Basin Setting Public Review Documents- Highlights and Discussion

Vina Subbasin Stakeholder Advisory Committee

September 15, 2020

Table 1-8. Water Budget Summary: Groundwater System.

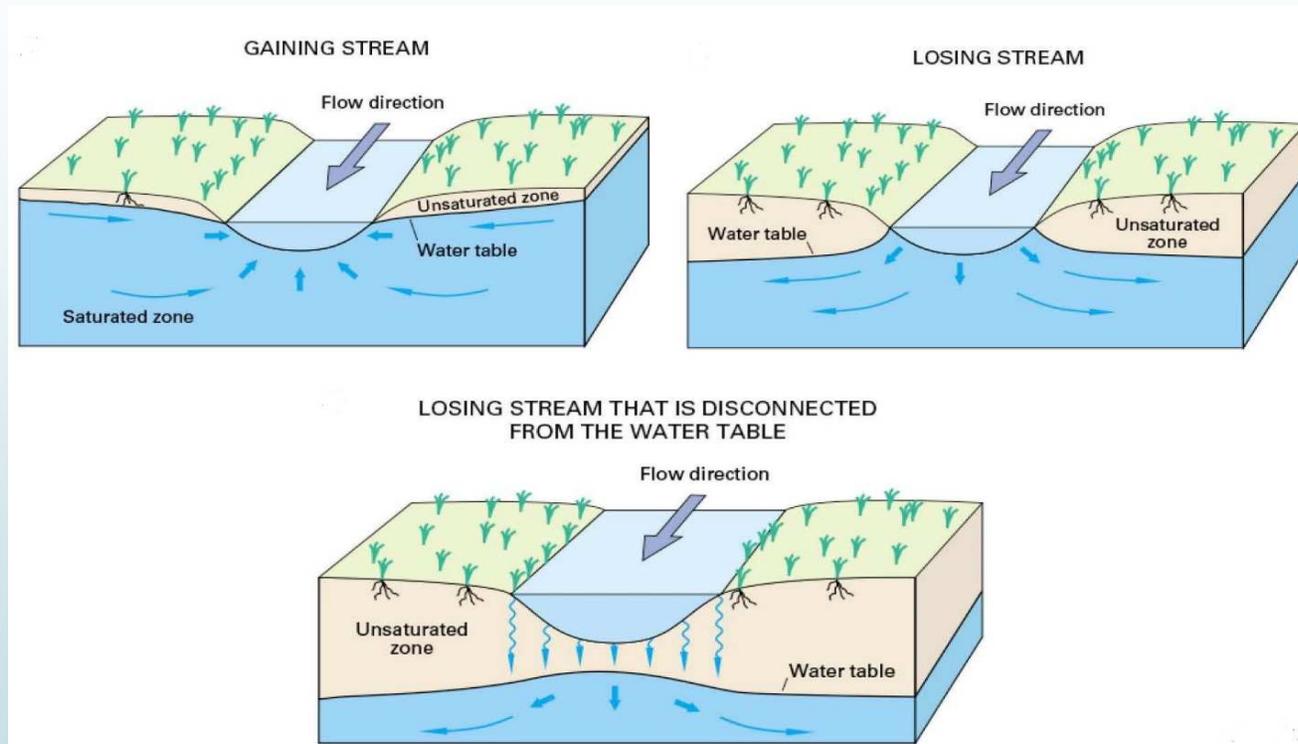
*Note corrected Total Inflow and Total Outflow
